SERVICE BULLETIN #1106

MODEL 1-71, 1-81 DATE 9/30/60

SUBJECT PREVENTION OF AIR LEAKAGE THROUGH FUEL TANK WICK

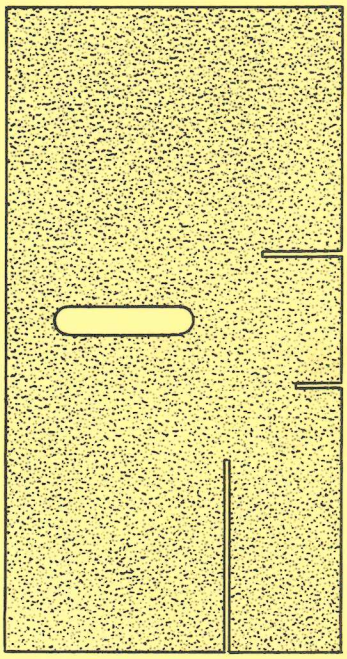
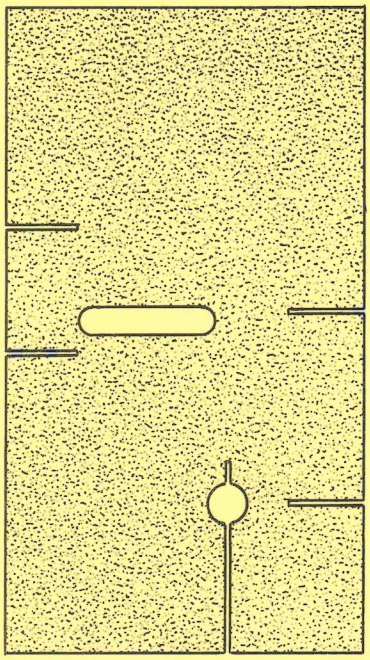
To prevent air leakage through the fuel pick-up, Fuel Tank Wick, P/N 55405, should be used in place of fuel tank wick, P/N 55676, on the above listed engines. The 55405 Fuel Tank Wick was used on 1-70 and 1-80 engines and is being installed in production 1-71 and 1-81 engines.

Dealers should change their 1-71 and 1-81 Illustrated Parts Lists by crossing out P/N 55676 (Figure 2, Index Number 17) and adding P/N 55405.
